**GEOLOGIC HAZARDS EVALUATION AND  
PRELIMINARY GEOTECHNICAL INVESTIGATION  
MAYBERRY – 540 ACRE SITE  
STATE HIGHWAY 94 AND LOG ROAD  
EL PASO COUNTY, COLORADO**

CTL|T Project No. CS18969.004-105

March 13, 2023

VICINITY MAP  
(NOT TO SCALE)

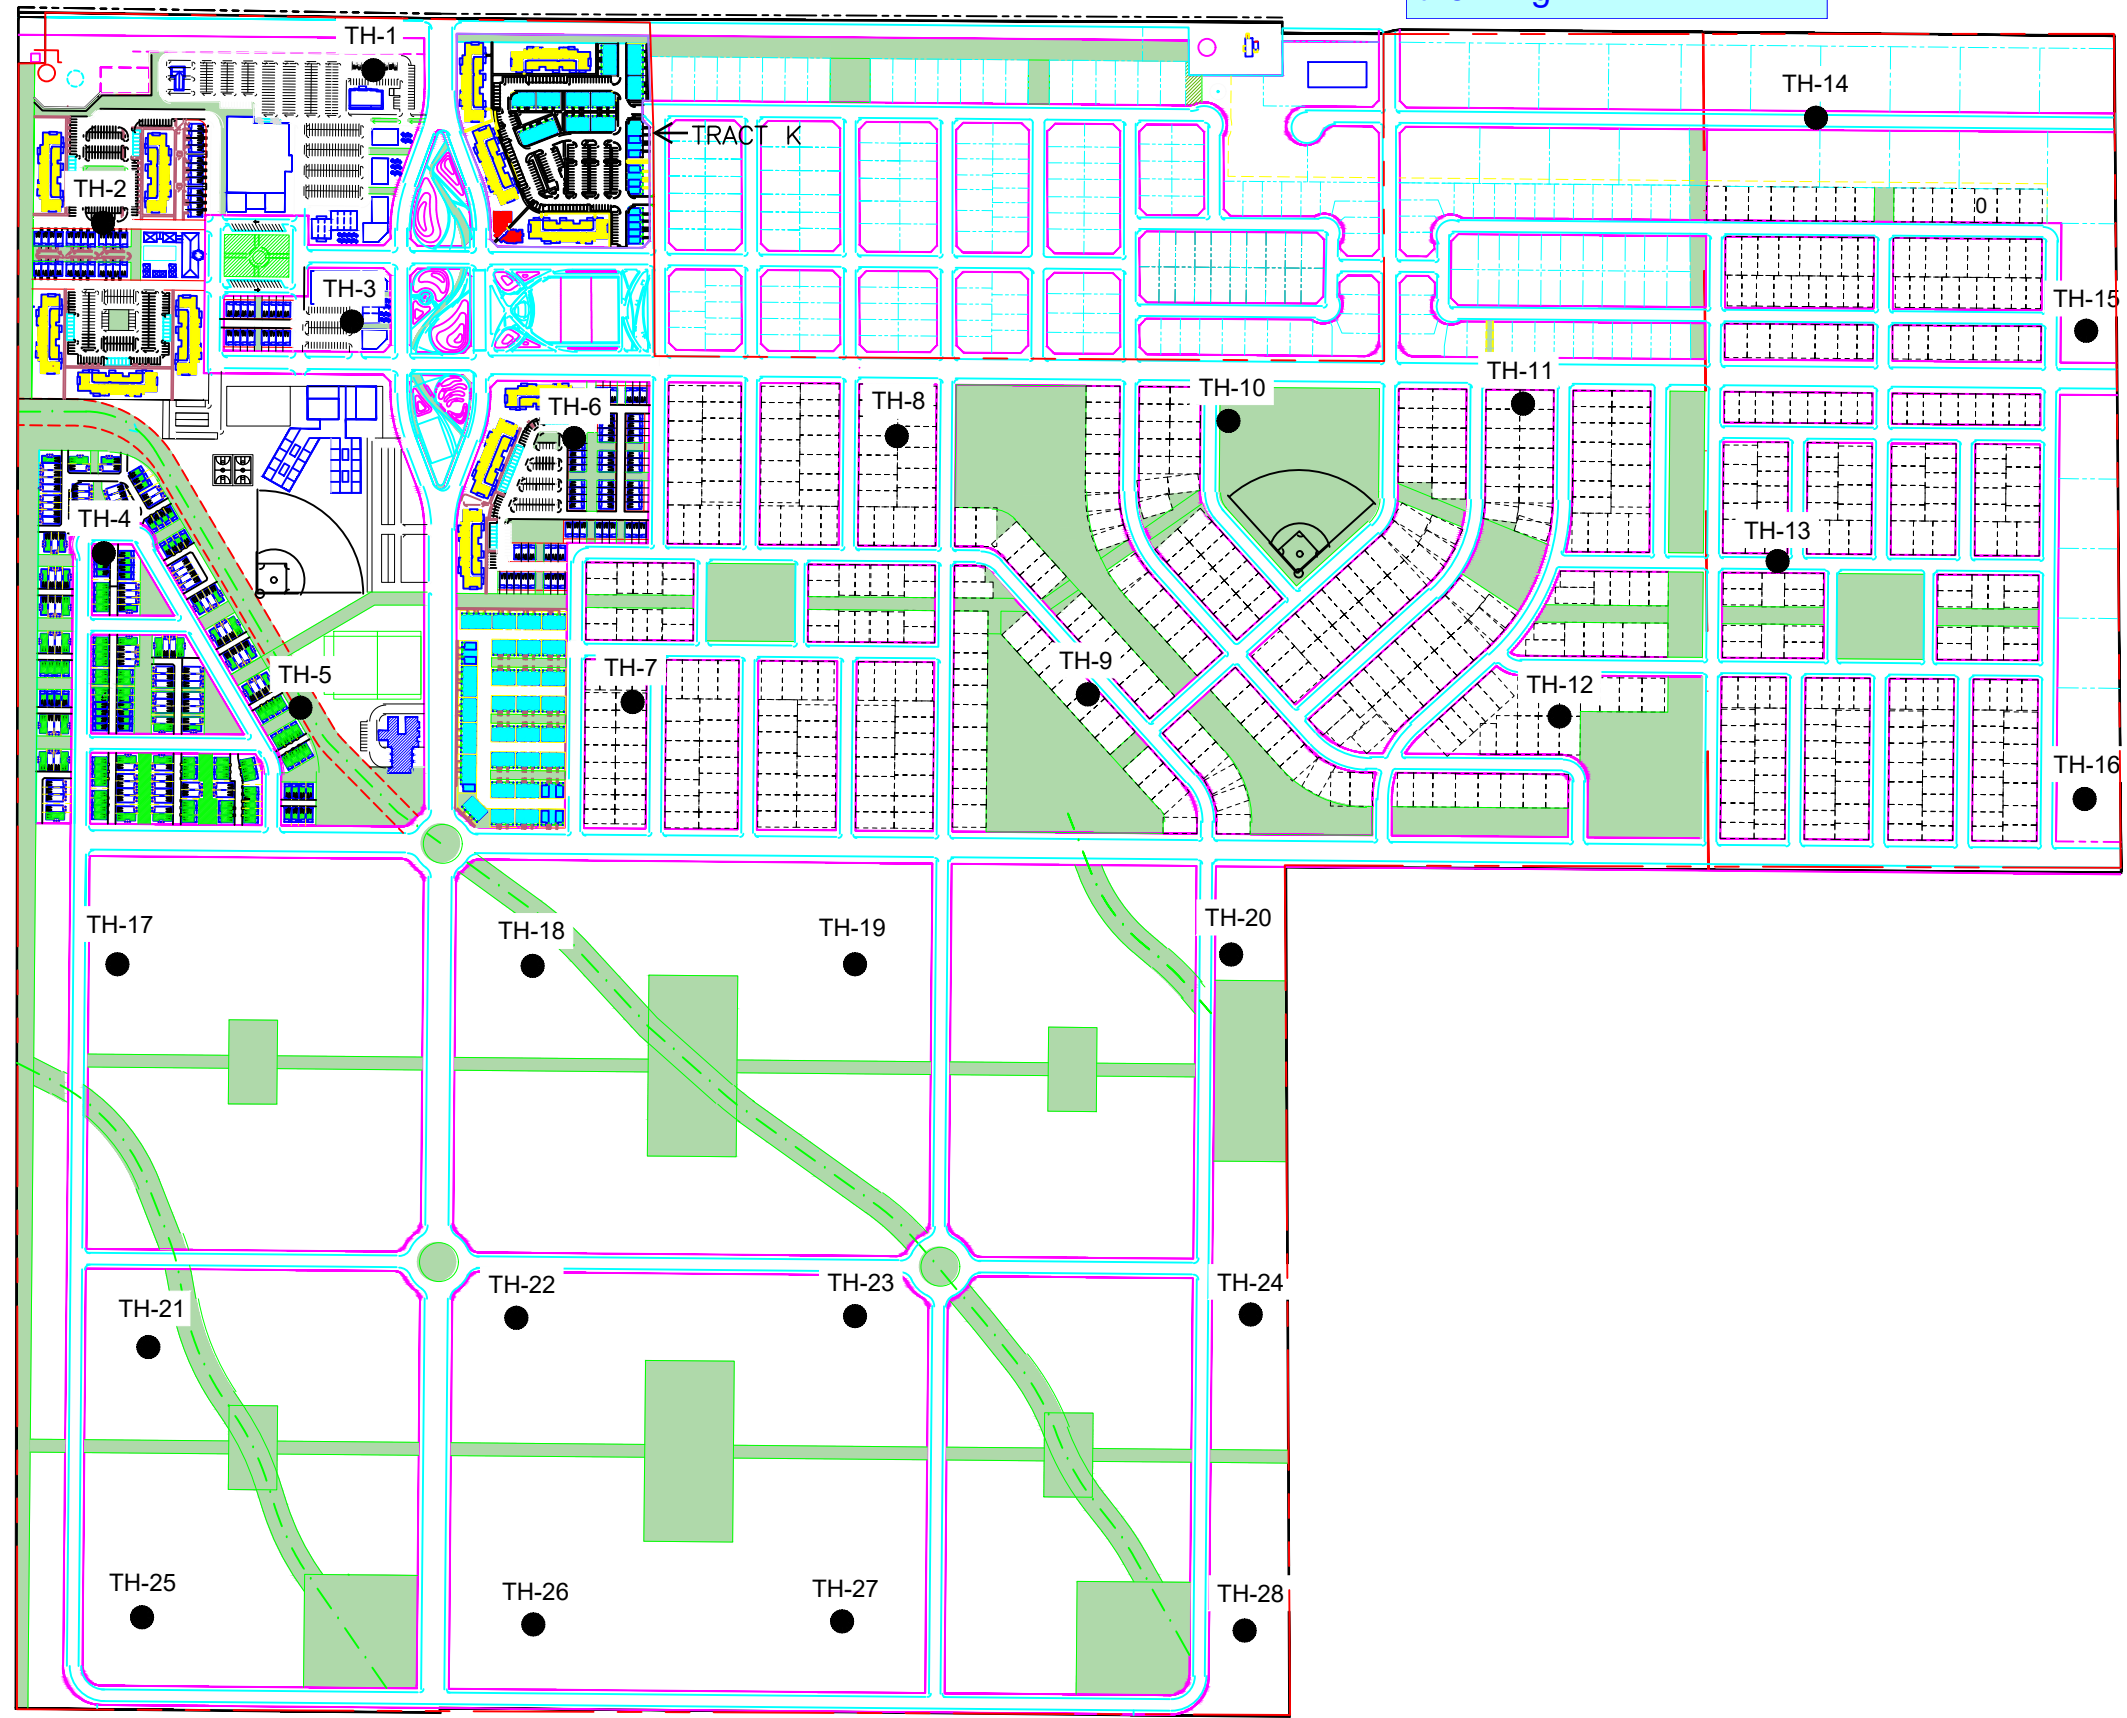
Ensure that the requirements of ECM C.3.3.B are met within the filing
